**RE: Paseo Marketplace
Conceptual Grading Plan
Stamp Date: 4/10/17
Hydrology File: D18D056**

**RE: Paseo Marketplace
Conceptual Grading Plan
Stamp Date: 3/2/17
Hydrology File: D18D056**

Attached is the revised Grading Plan for Paseo Marketplace. The following addresses the comments received on March 31st, 2016 regarding the submittal to the City of Albuquerque on March 3rd, 2016:

SHEET NUMBER:
C-1

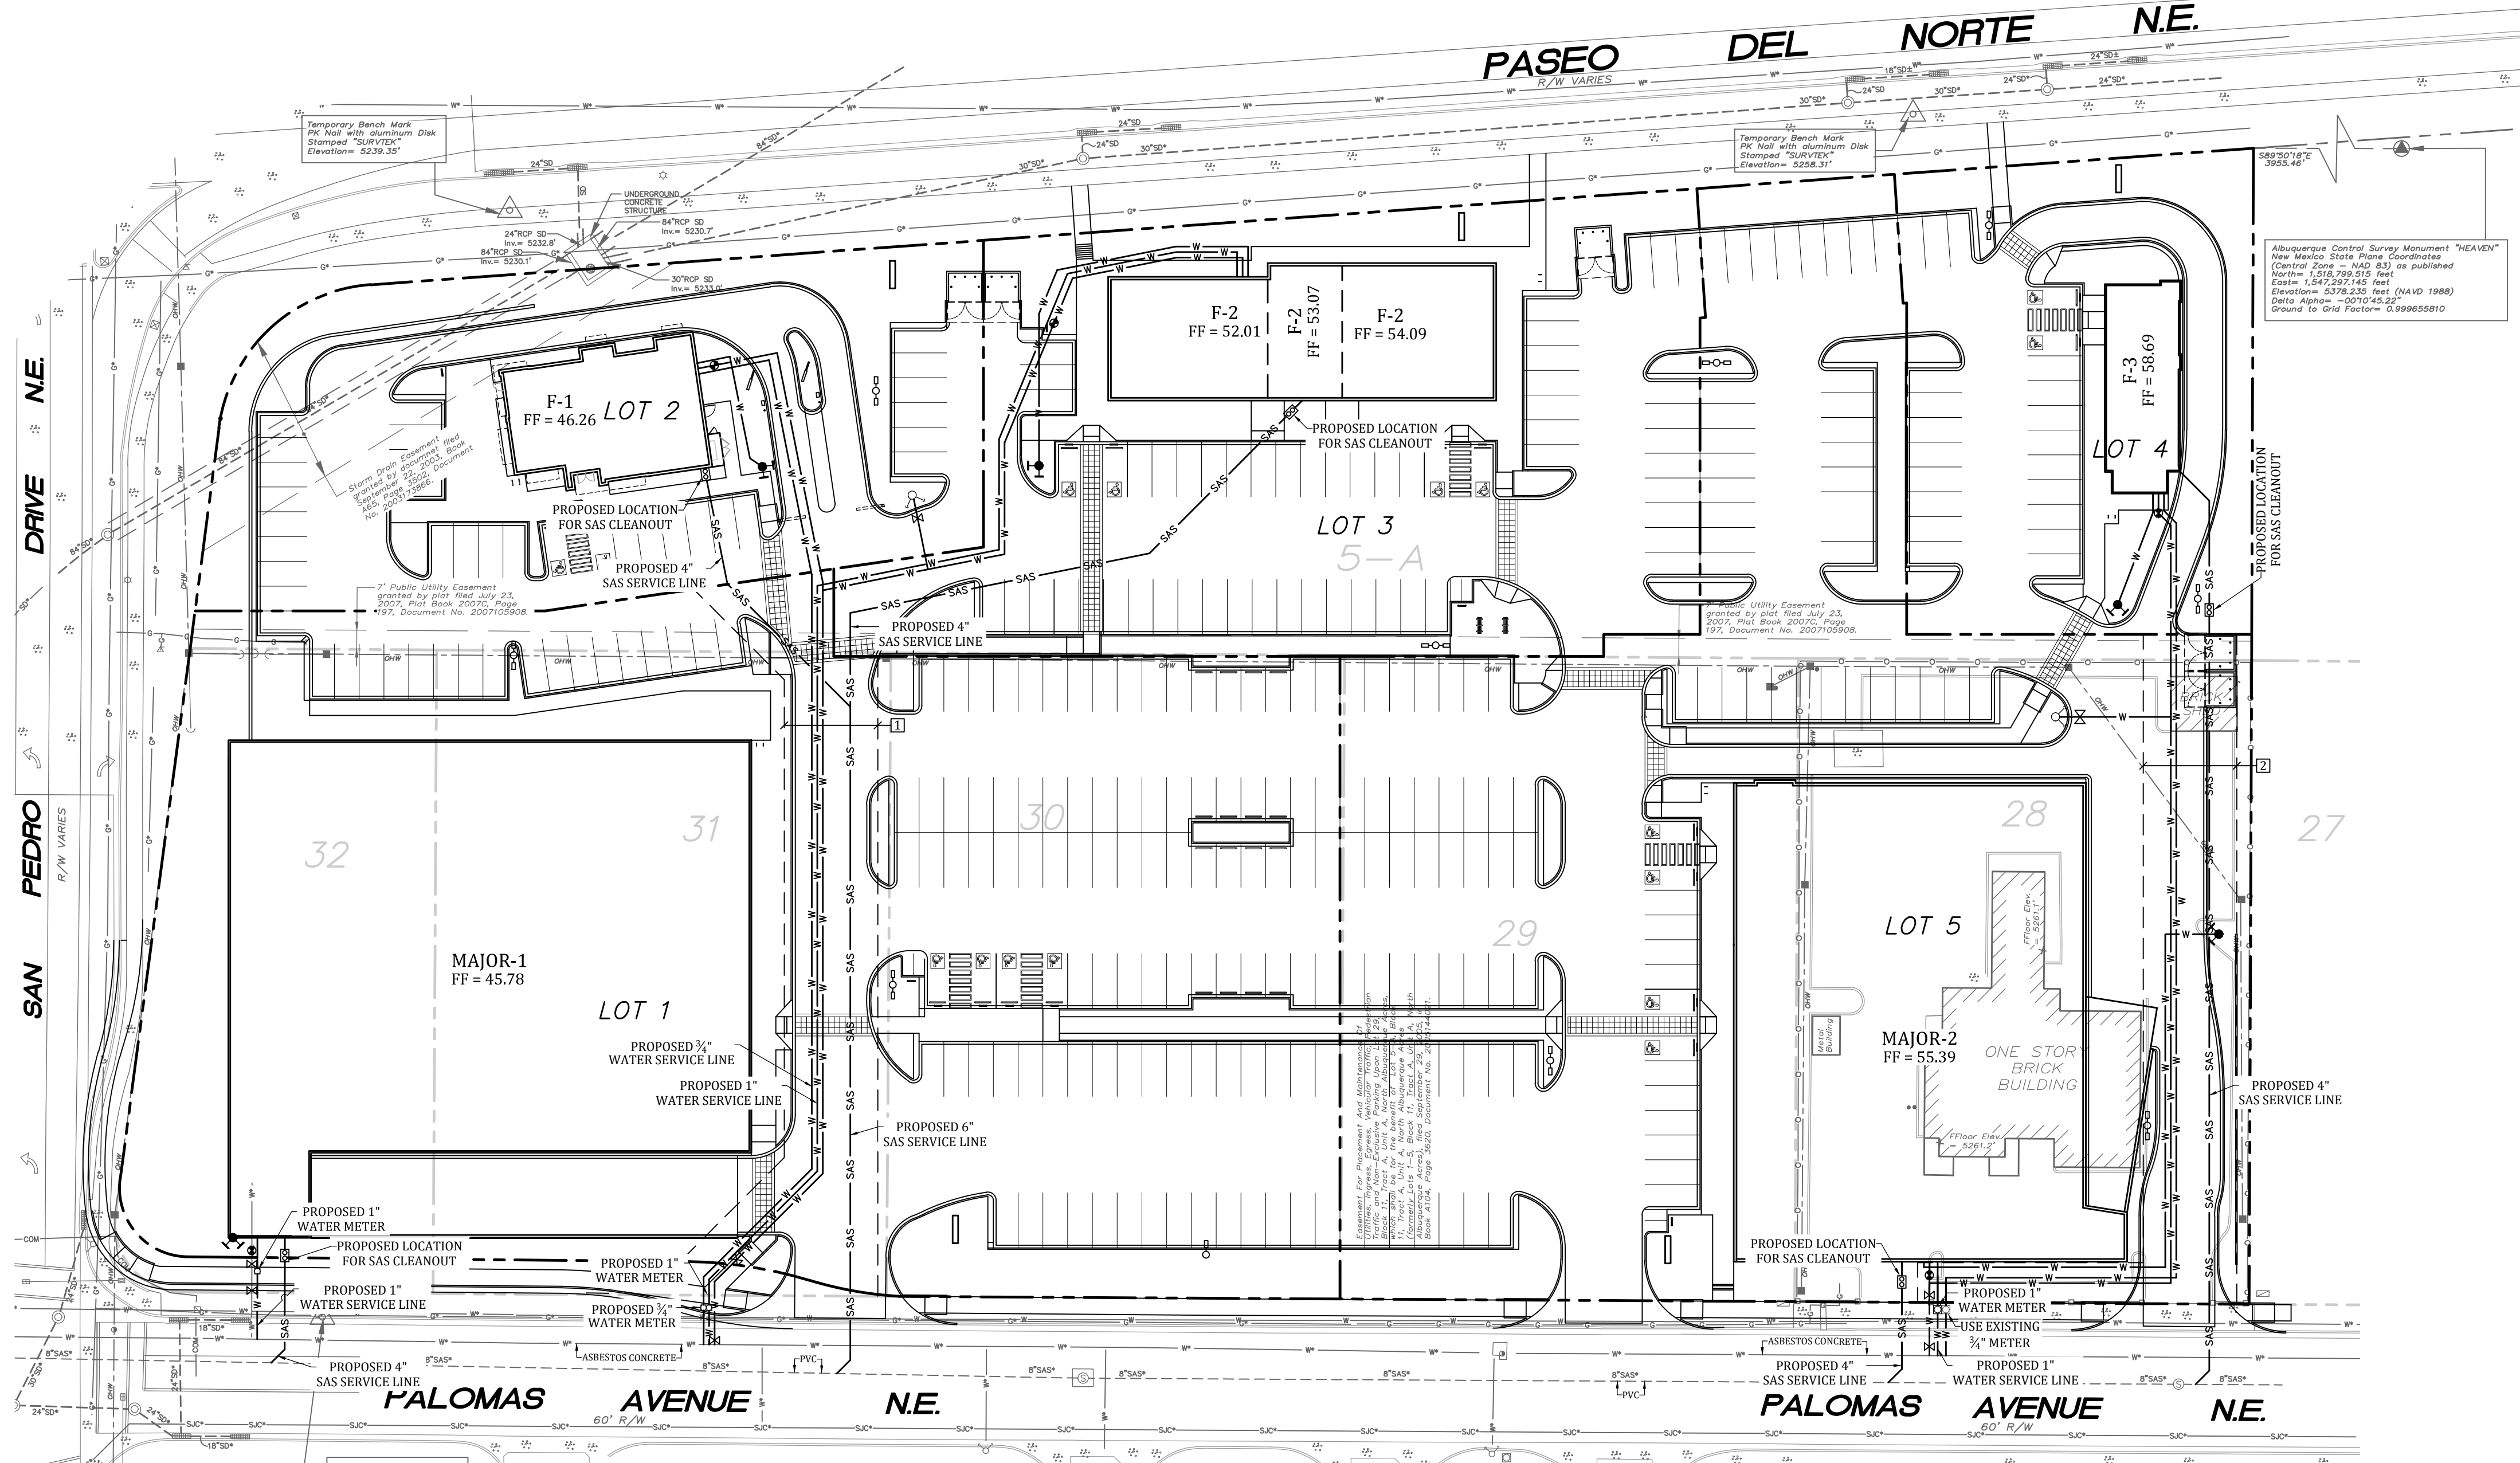
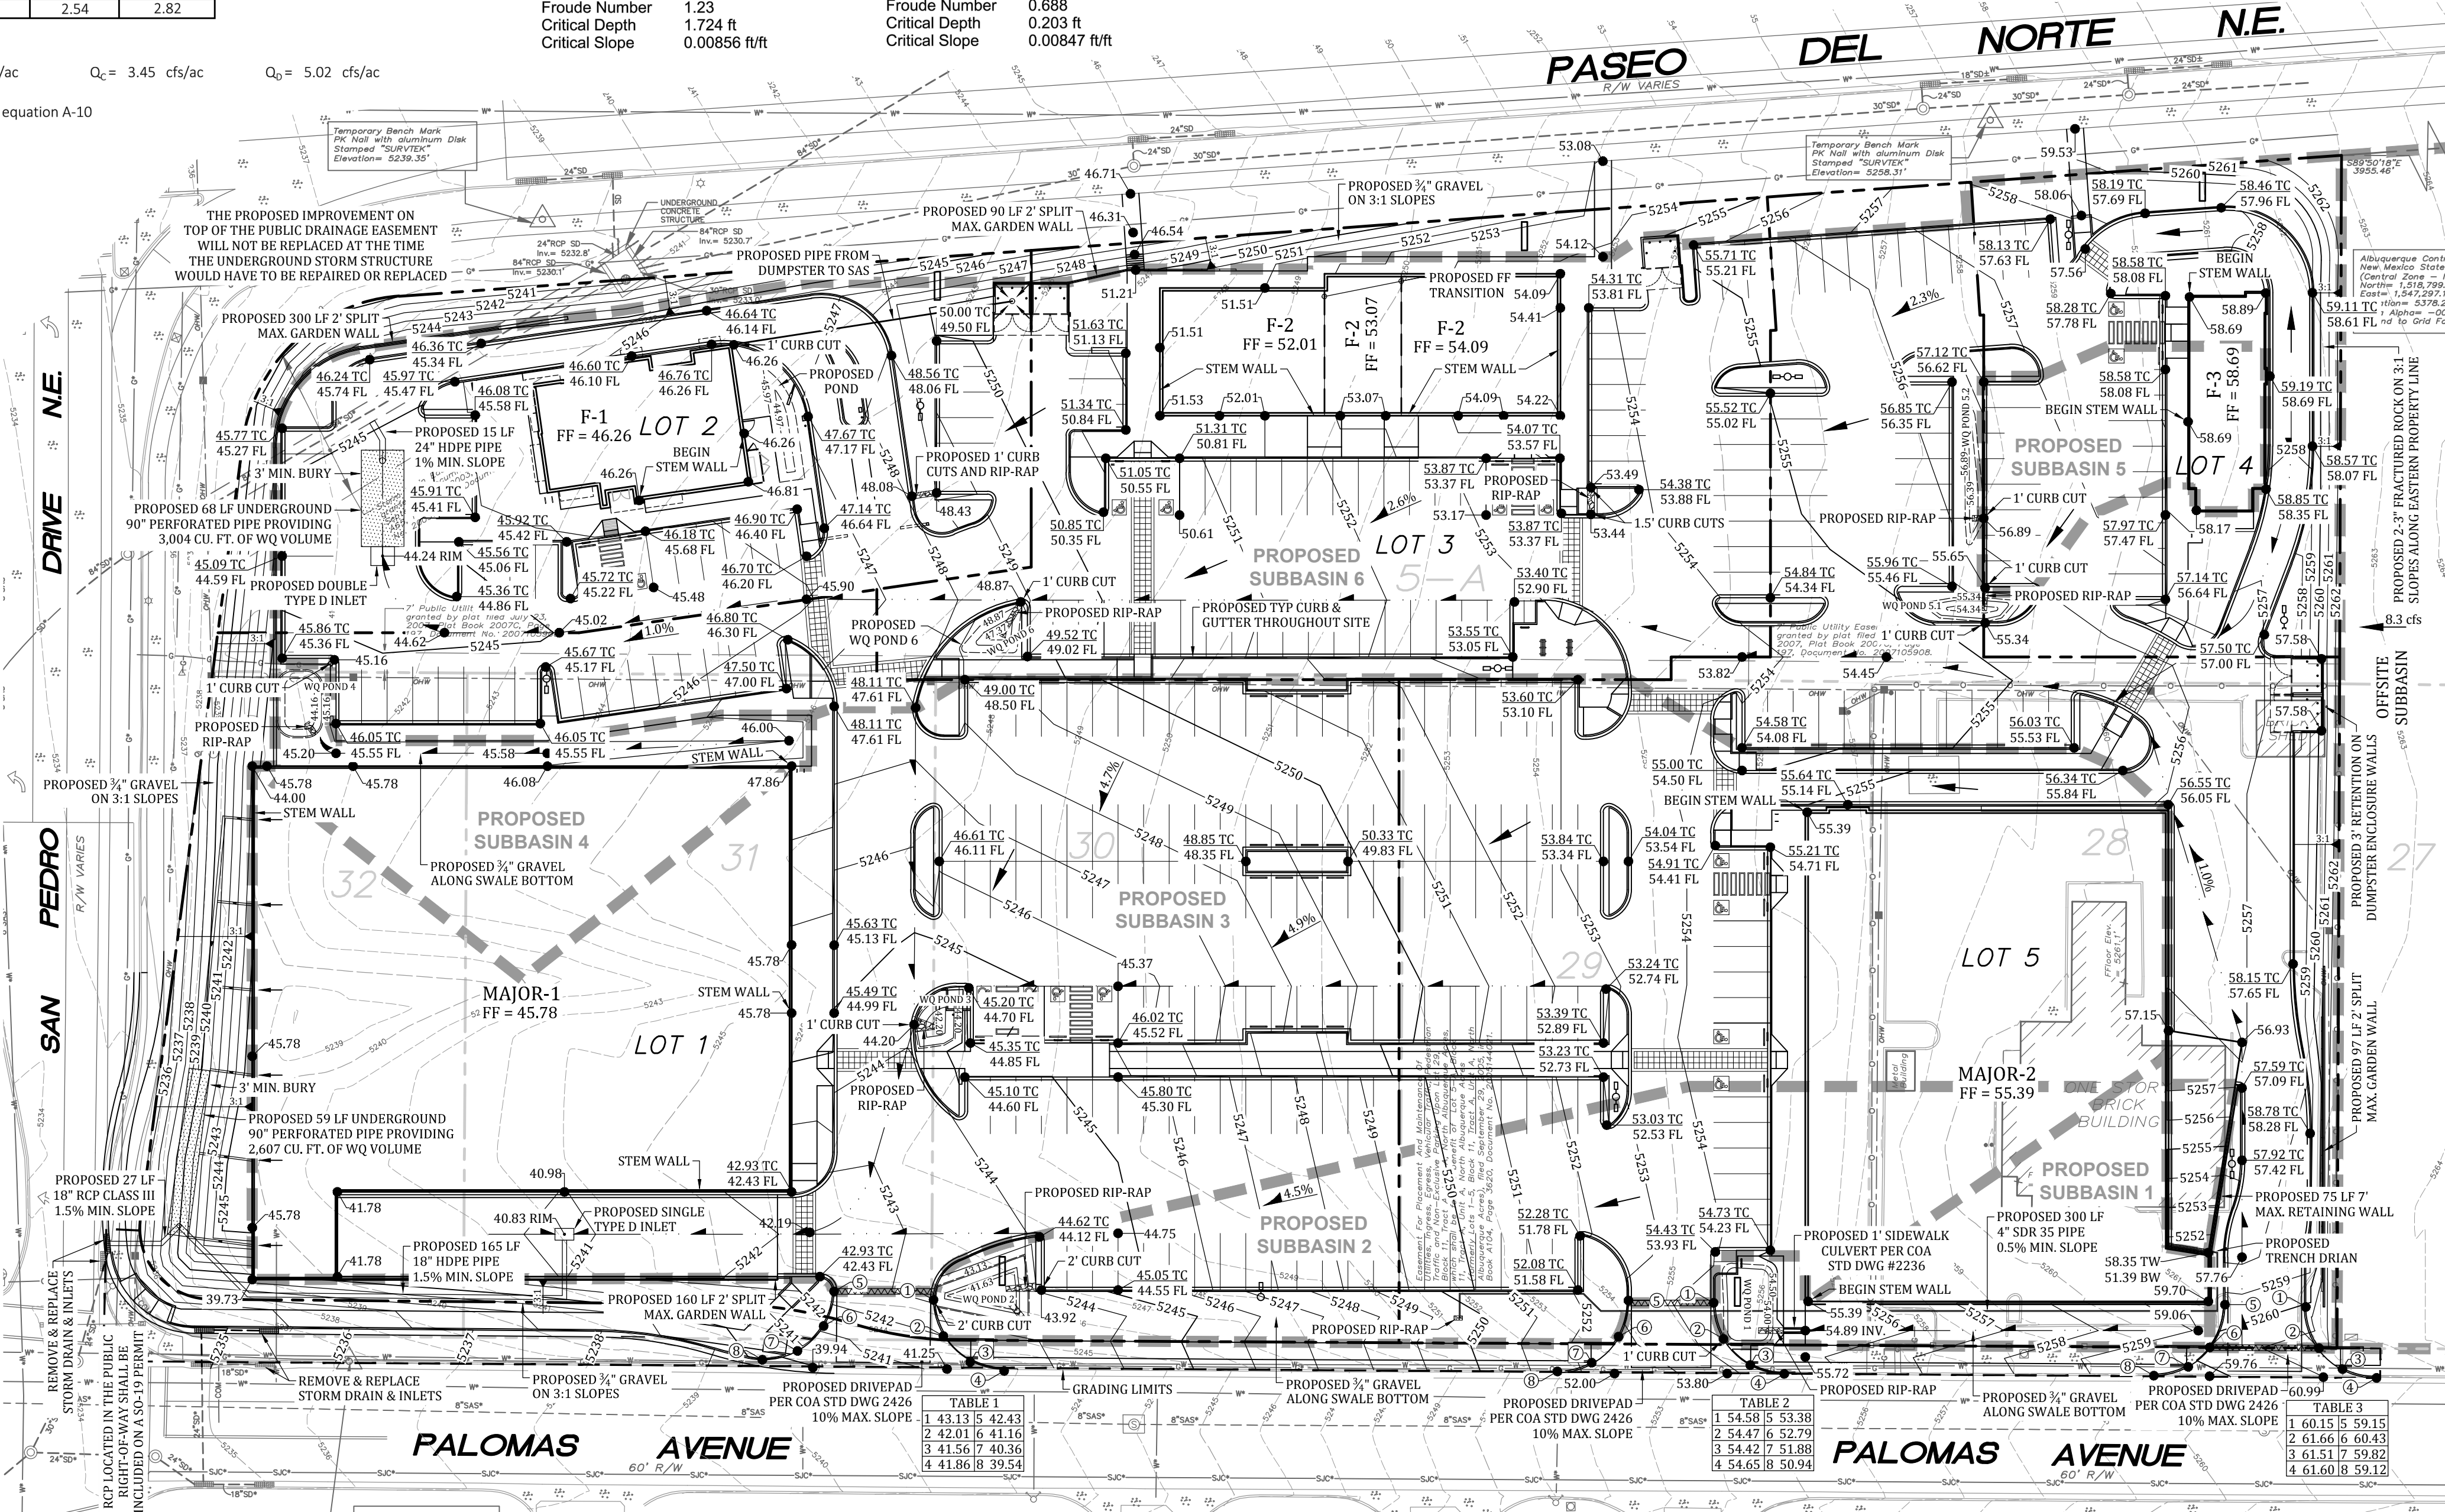
2. For your water quality pond for the subbasin 1, you are proposing a fire dept conn. for Bldg Major-2. Please shift this closer to the building and out of the water quality pond.

4. The proposed conditions section was a little hard to read. You might want to either add some space between the proposed subbasins or place all the information in a separate 8 ½ x 11 drainage report. This could also allow you to bring the site to a 1"=30' scale which would also make the Conceptual Grading Plan more readable as well.

5. For the proposed truck ramp, you call out a 4" NDS grate. I'm concerned about clogging of this inlet. Typically for a truck ramp, one places a French drain which can be easily cleaned out and if partially clogged, it will still function. You might want to take another look at this.

6. In Proposed subbasin 6, you have one building listed as Food. Just a reminder that for the drainage from the dumpster for this building will need to drain into the sanitary sewer.

The fire department connection has been relocated to the east side of Bldg Major-2. See updated plans.

The proposed conditions section has been separated into paragraphs for each subbasin. See updated plans. The scale remains a 1"=40' because the site development plan for building permit checklist requires that the Grading and Drainage Plan matches the scale on the Site Plan.

A trench drain has been added at the truck ramp for Bldg Major-2. See updated plans.

The dumpster area has been revised to drain into the sanitary sewer for the building. See updated plans.
